REPORT OF: URBAN DESIGN COMMISSION	PRESENTED: October 19, 2011
TITLE: 722 Williamson Street – PUD(GDP) for a 34-Unit Mixed-Use Building. 6 th Ald. Dist. (23566)	REFERRED: REREFERRED: REPORTED BACK:
AUTHOR: Alan J. Martin, Secretary	ADOPTED: POF:
DATED: October 19, 2011	ID NUMBER:

TITLE: Aprox. 306 Livingston – Third Lake Ridge Historic District – Construction of new 5-story mixed-use development including 39 apartment units (currently on parcel of 722 Williamson) – 6th Ald. District. Contact: Randy Bruce and Marty Rifken (23433)

Regarding: **Approx. 306 Livingston Street – Third Lake Ridge Historic District – Construction of new 5 story mixed use development including 39 apartment units (currently on parcel of 722 Williamson). 6th Ald. District. (Legistar #23433)**

306 South Livingston Street
 Visually Related Study Area
 Landmarks Commission - 8/2011

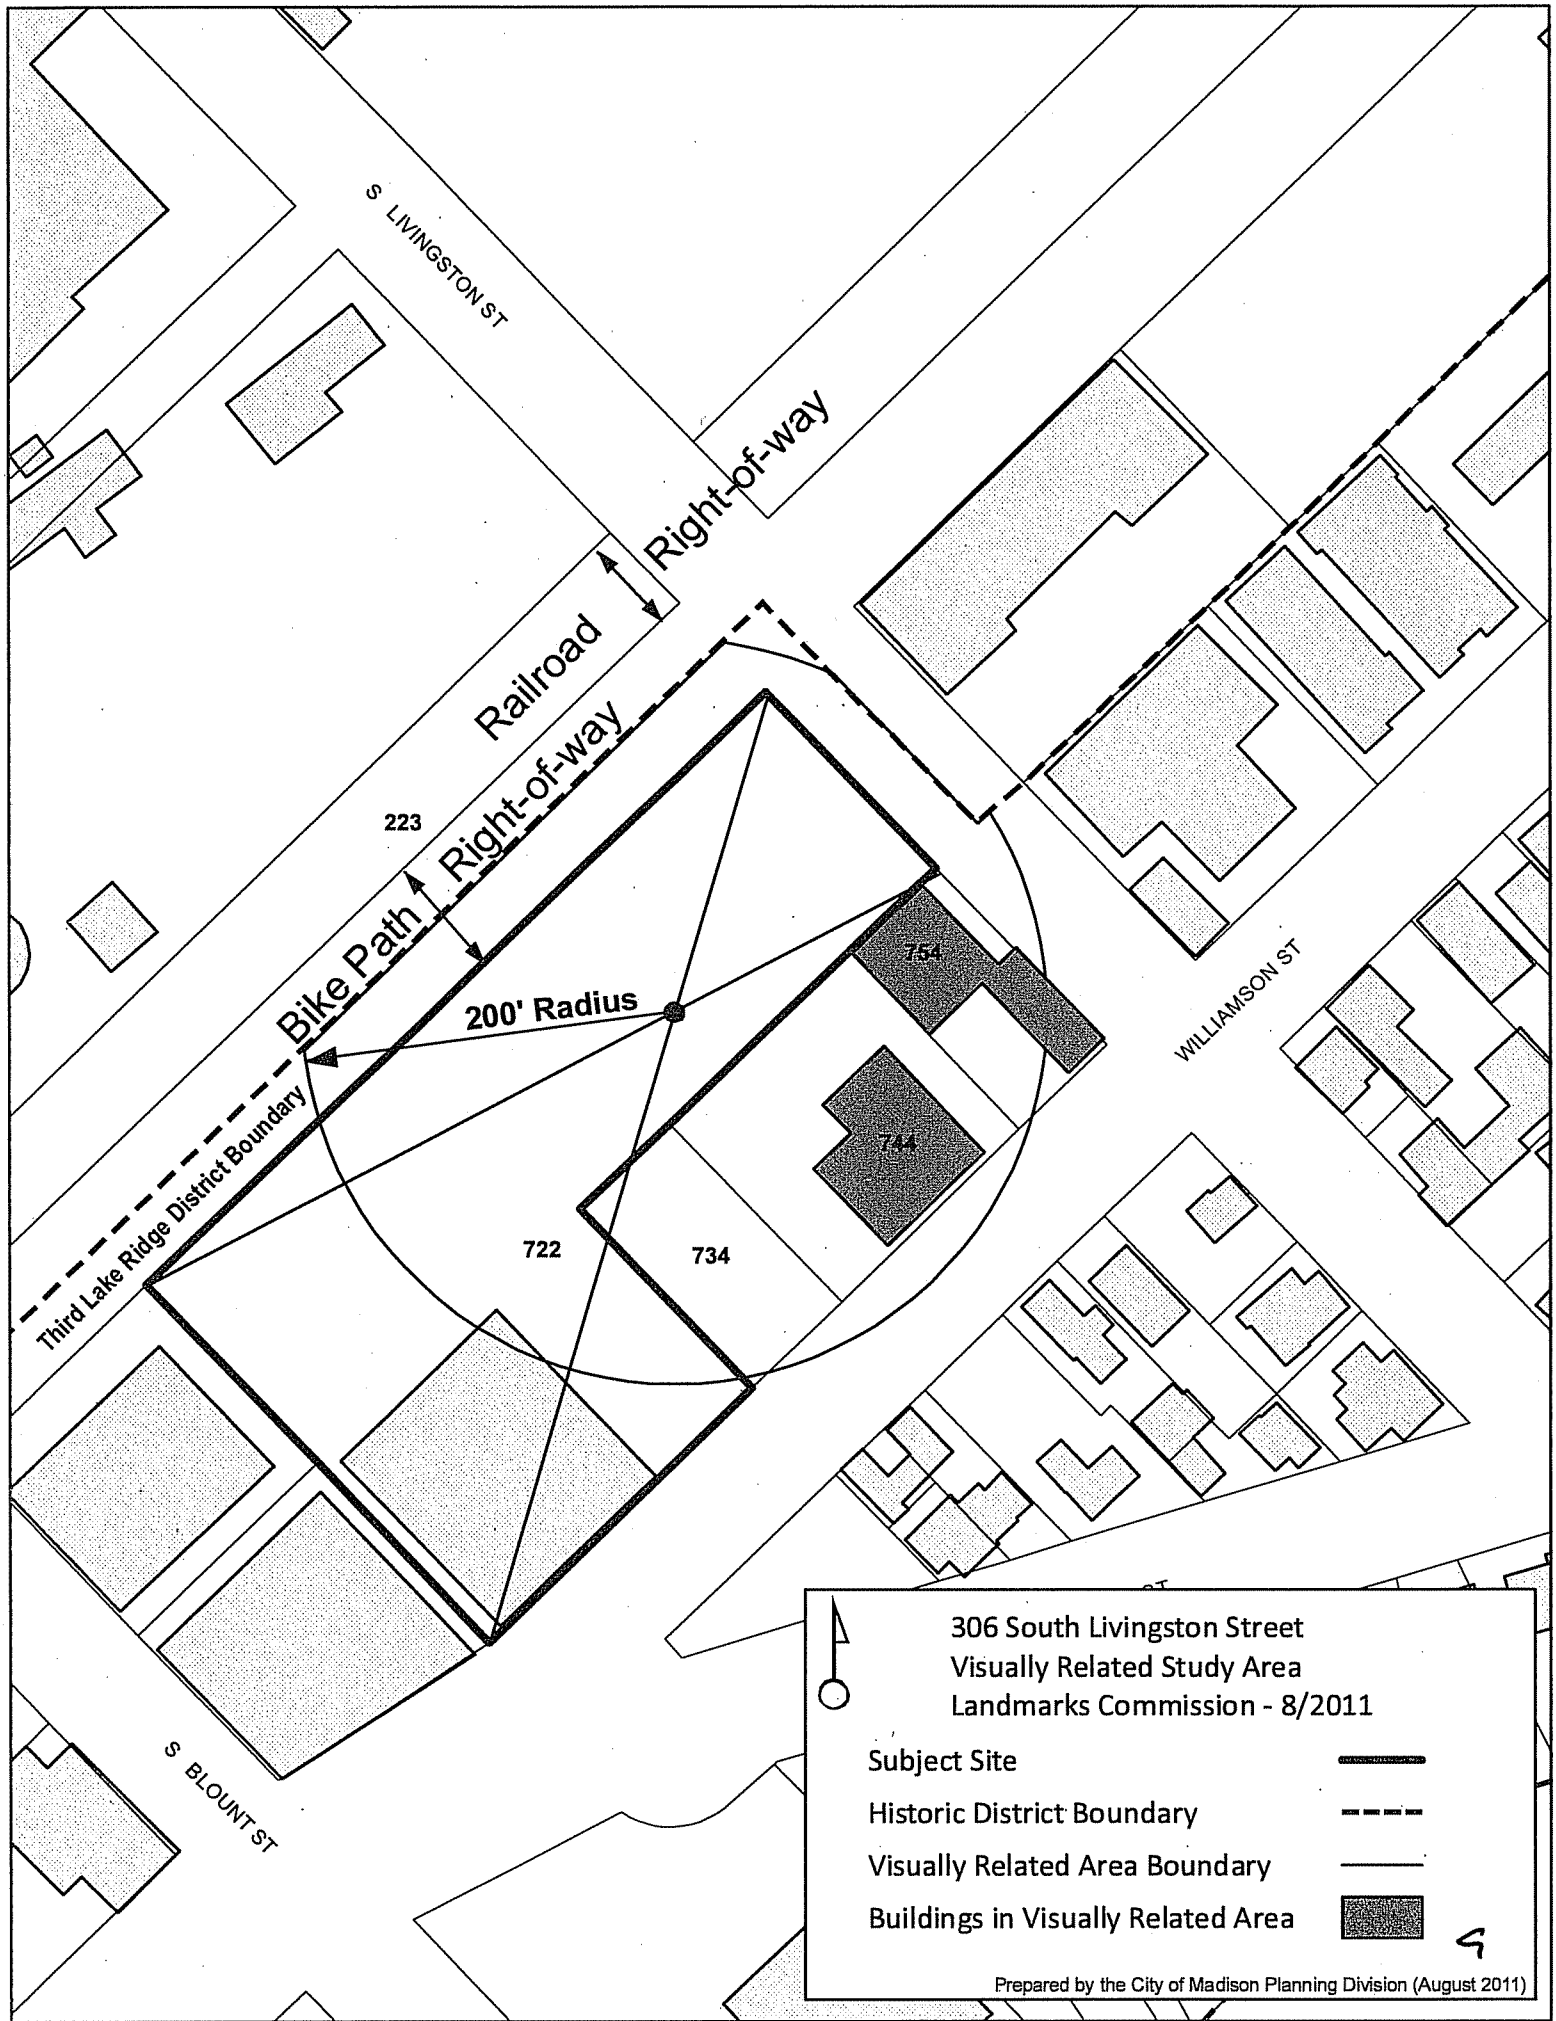
1. Any new structures shall be evaluated according to both of the criteria listed in Sec. 33.01(11)(d); that is, compatibility of gross volume and height.
2. The rhythm of solids and voids in the street facade(s) of any new structure shall be compatible with the buildings within its visually related area.
3. The materials used in the street facade(s) of any new structure shall be compatible with those used in the buildings and environment within its visually related area.
4. The design of the roof of any new structure shall be compatible with those of the buildings and environment within its visually related area.
5. The rhythm of building masses and spaces created by the construction of a new structure shall be compatible with the existing rhythm of masses and spaces for those sites within its visually related area.

Staff appreciates the revisions that have been made to the proposed building design which include the traditional treatment and proportion of windows, the increased use of masonry as continuous wall planes, and the development of architectural details (substantial belt course, inset grouped windows, and the masonry piers along the bike path elevation); however, staff believes that further design development as described below will allow the building to be more compatible within the historical context of the site.

1. The brick color should be changed to a darker color which would be more compatible with the materials in the visually related area and in the overall context of that portion of the district. A review of structures within the visually related area and the surrounding context indicates a predominant use of darker, mostly red, brick as the primary building material.

2. The building should have a "top" with the expression of a more substantial cornice at the termination of the masonry at the 4th floor in an effort to be compatible with the perceived heights of buildings in the visually related area and in the overall context of that portion of the district.

3. The change in wall materials (from brick to metal) at the stair towers results in a vertical break in the masonry wall surface which indirectly interrupts the rhythm of solids and voids in the elevation. Staff suggests the continuation of the masonry material at the stair towers to unify the elevation and make it more compatible with other buildings in the visually related area and in the overall context of that portion of the district.
